LPA Ref: 22/00752/OUT

Forest Hill Golf Club, Botcheston

Appeal Statement (Highways)

(August 2023 Revision B)

Figure 1: Speed survey locations.

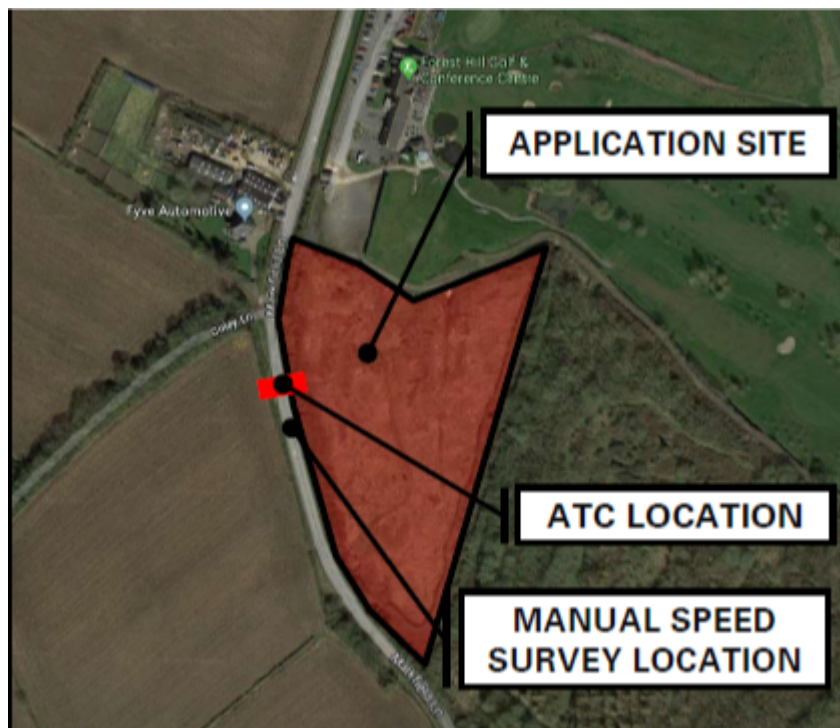
The LHA previously requested clarity as to where both the manual speed survey and Automatic Traffic Count (ATC) speed survey were undertaken, as there were discrepancies within the original Transport Assessment (TA) as to exactly where the surveys were undertaken. The Applicant has detailed the surveys were undertaken in the locations detailed in Figure 1.

The LHA also requested clarity as to why the hand radar survey had been selected when the ATC survey gathered data over a considerably longer period which would give a more accurate picture of the speeds in this area.

Figure 1: Speed survey location.

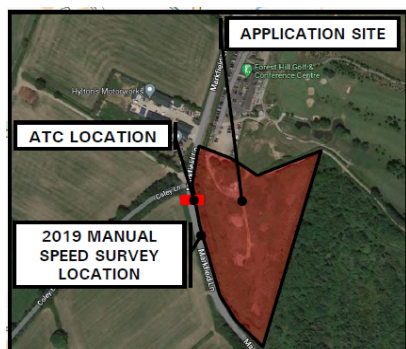
It should be noted the LHA did not accept results of the manual speed survey as part of the previous application and advised the ATC data was considered to be more robust. The locations of the surveys are shown in Figure 1.

The Applicant has used the 2022 speeds in order to calculate visibility. Based on Part 3, Table DG4 of the Leicestershire Highway Design Guide ([LHDG], available at <https://resources.leicestershire.gov.uk/lhdg>), where measured vehicle speeds fall between 45 - 53mph, visibility splays of 2.4 x 160 metres would be required. The Applicant has stated that Manual for Streets 2 (MfS2) guidance has been used and proposed splays of 2.4 x 133 metres in a north-westerly direction and 2.4 x 126 metres in a south-easterly direction. Forward visibility of 126 metres for vehicles travelling northbound has also been detailed by the Applicant.

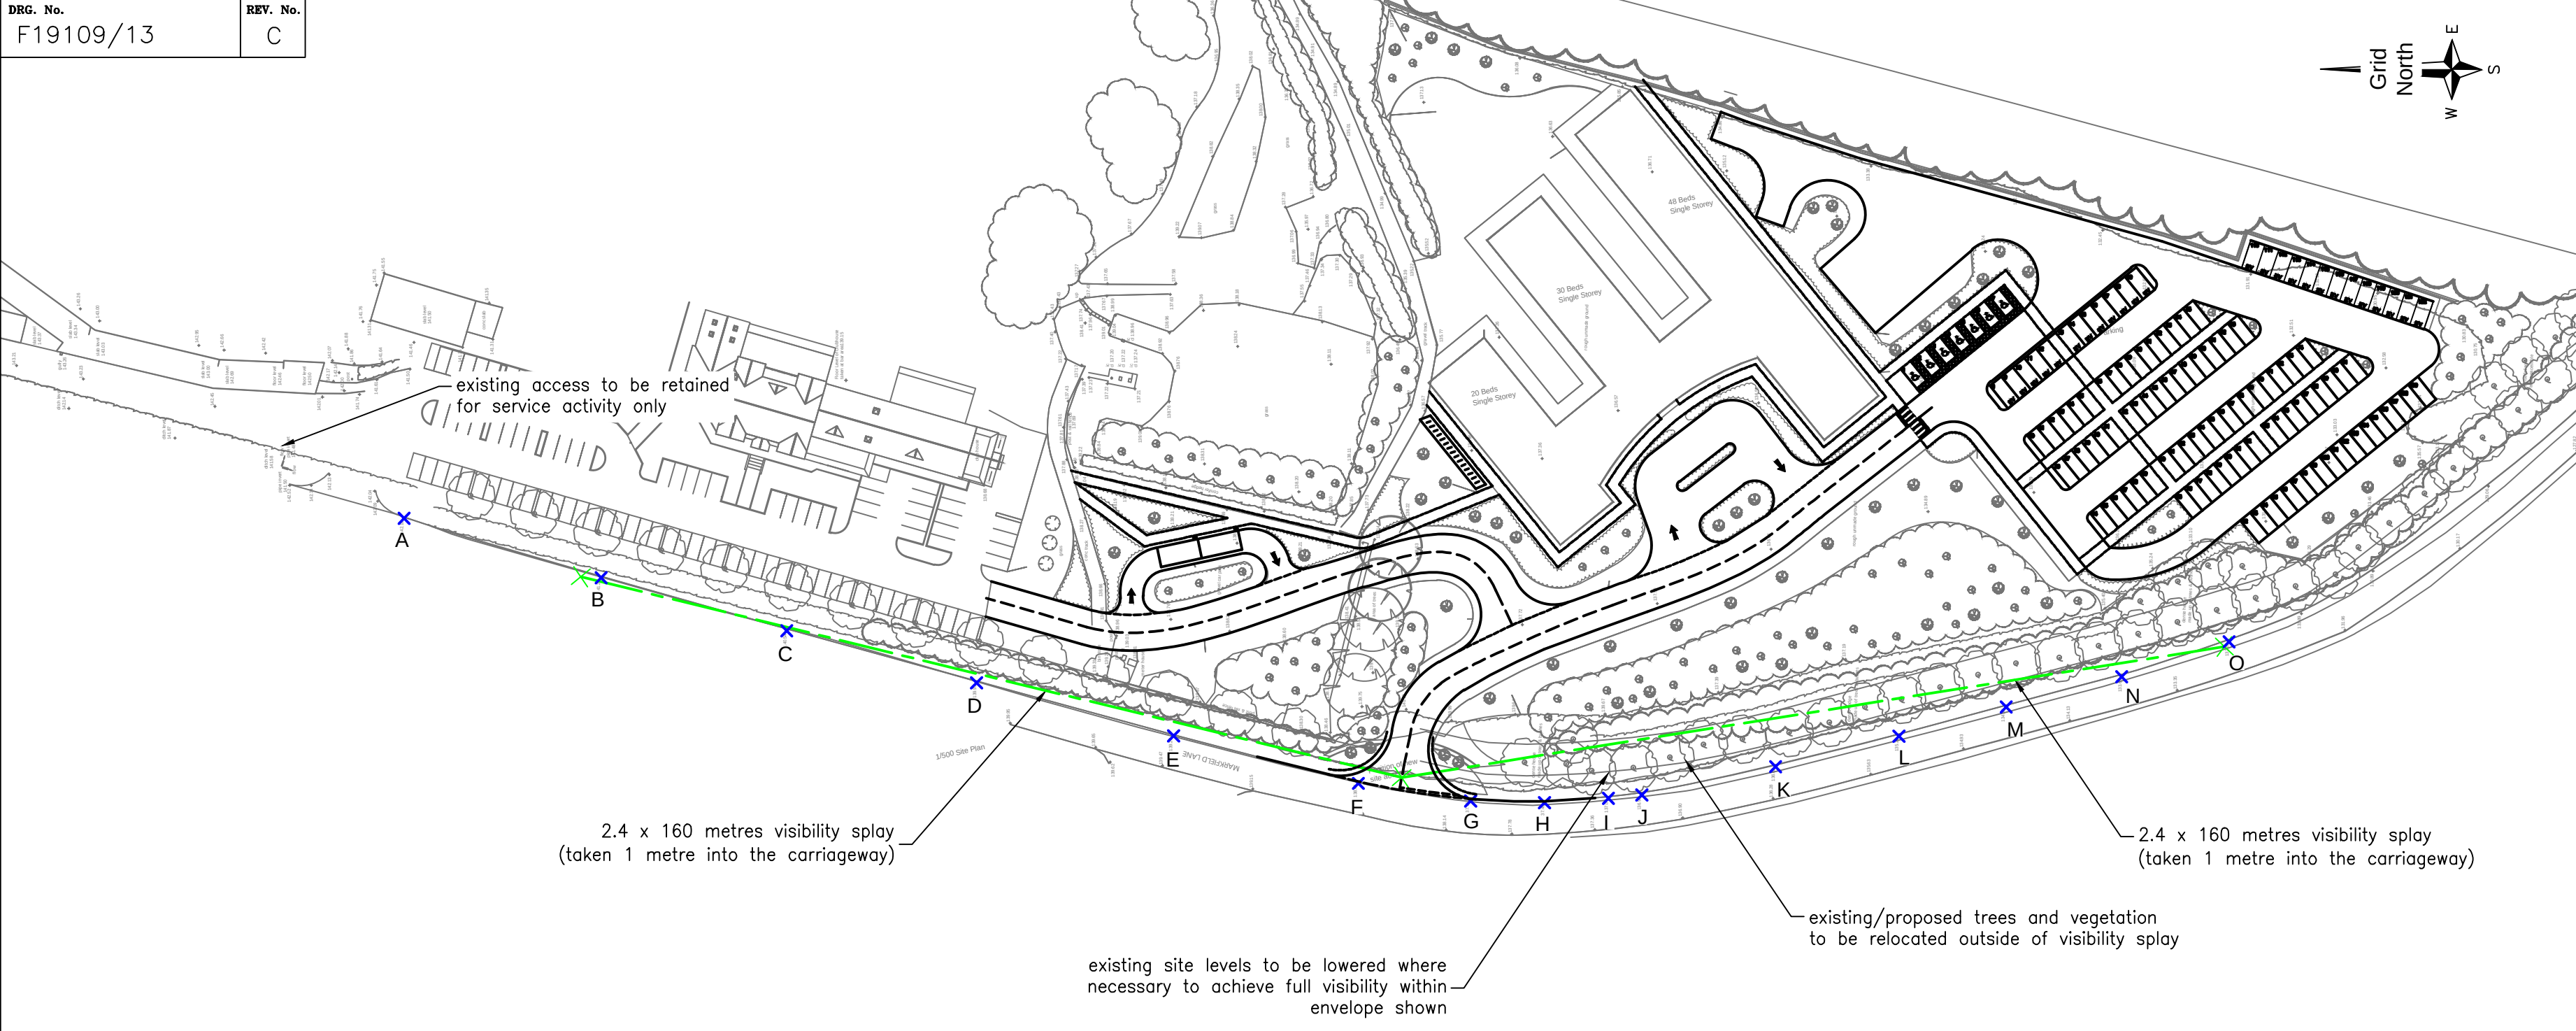
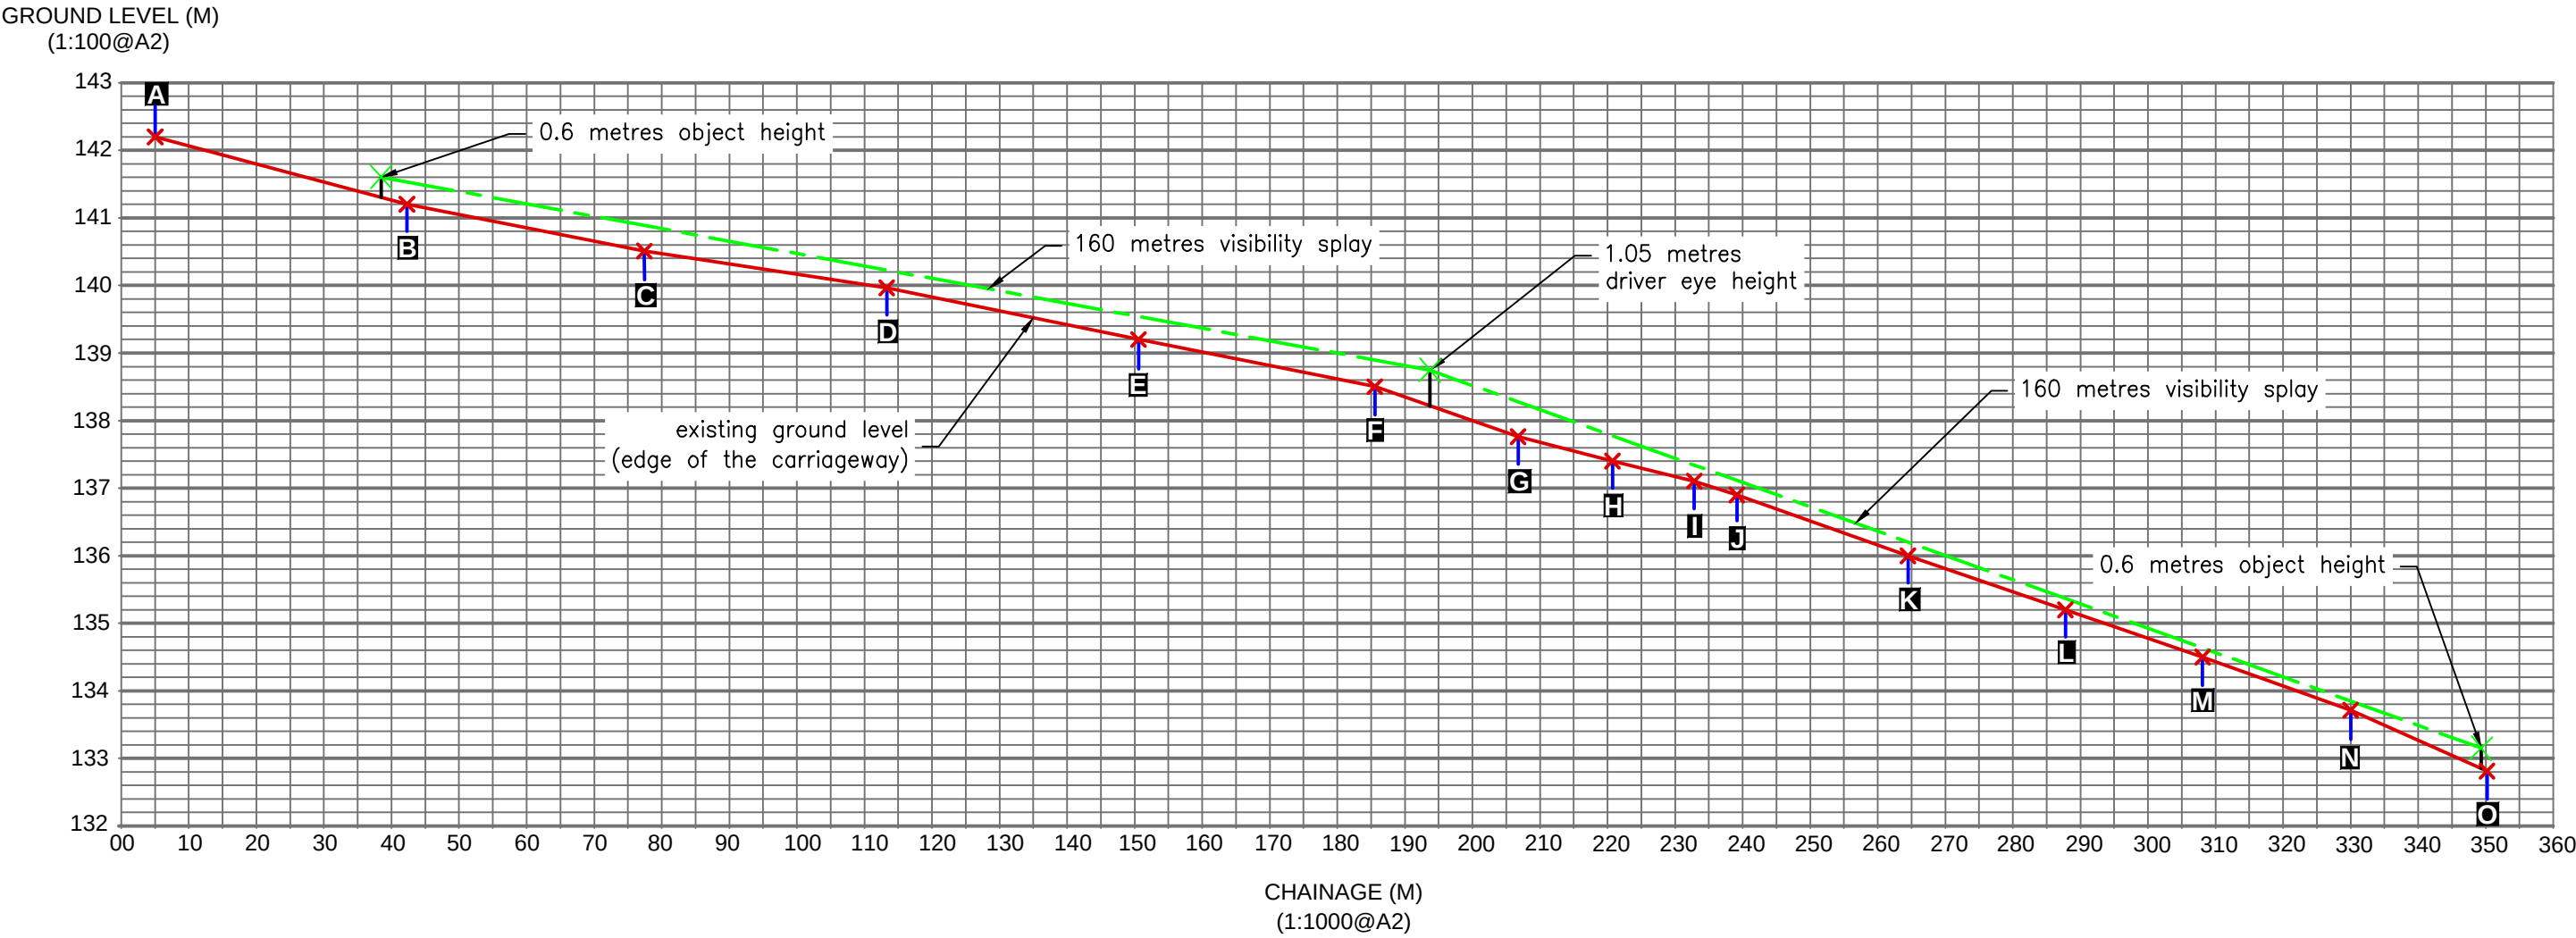
One other concern raised by the Highway Authority relates to the angle of driver position as they emerge from the site, primarily for drivers looking south for oncoming vehicles. This is a point that was picked up on the Road Safety Audit. Although it is fair to say that the junction layout does not follow the conventional straight approach for the major and minor arms, this is not an uncommon situation and there is ample visibility both for emerging drivers and approaching drivers to safely facilitate the manoeuvre. Interestingly Figure DG2a of the published Leicestershire Highways Design Guide even presents an almost identical scenario in how to deal with the delivery of splays at T-junctions, with Table DG5 presenting numerous examples of 'skewed junctions' within its representation of *"Broad junction types"*. It is therefore considered unreasonable to simply conclude that the splay alignment to the south will lead to any specific highway safety problem at this access.

enc. **Drawing Number F19109/13 Revision C** – Proposed access layout with
alternative visibility assessment
